NUMBER: 83-7

POWER TRIM PUMP INSPECTION/REPLACEMENT

a - Date Code
Figure 1

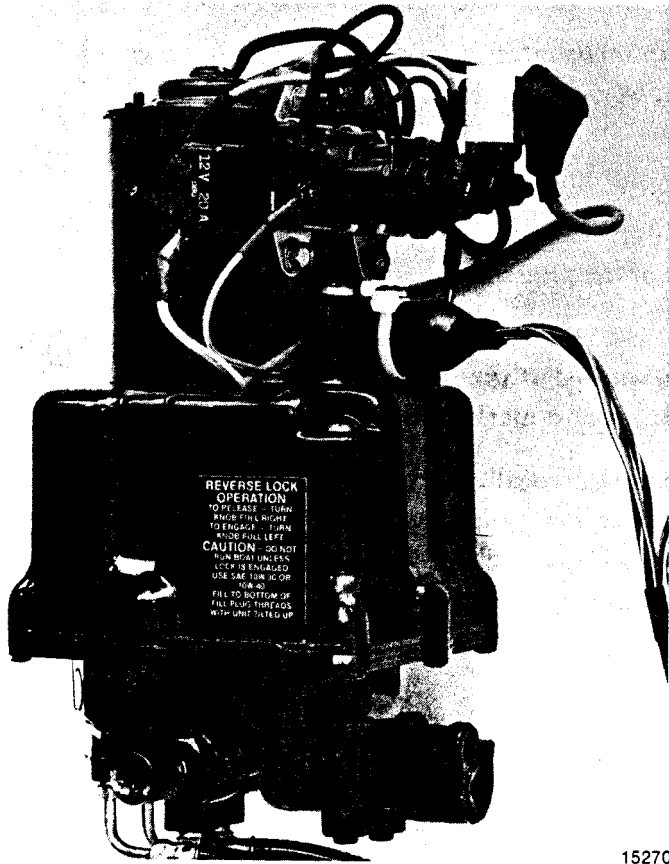
Inspect the date code located at the bottom of the hydraulic pump assembly (Figure 1). Any date code shown as **1-83** thru **17-83** requires rework of the pump motor assembly P/N **92975A22** (Figure 2). Order hydraulic rework kits (part number **392-9228**) for reworking the pump motor from your Distribution Center. Installation instructions are included with each rework kit.
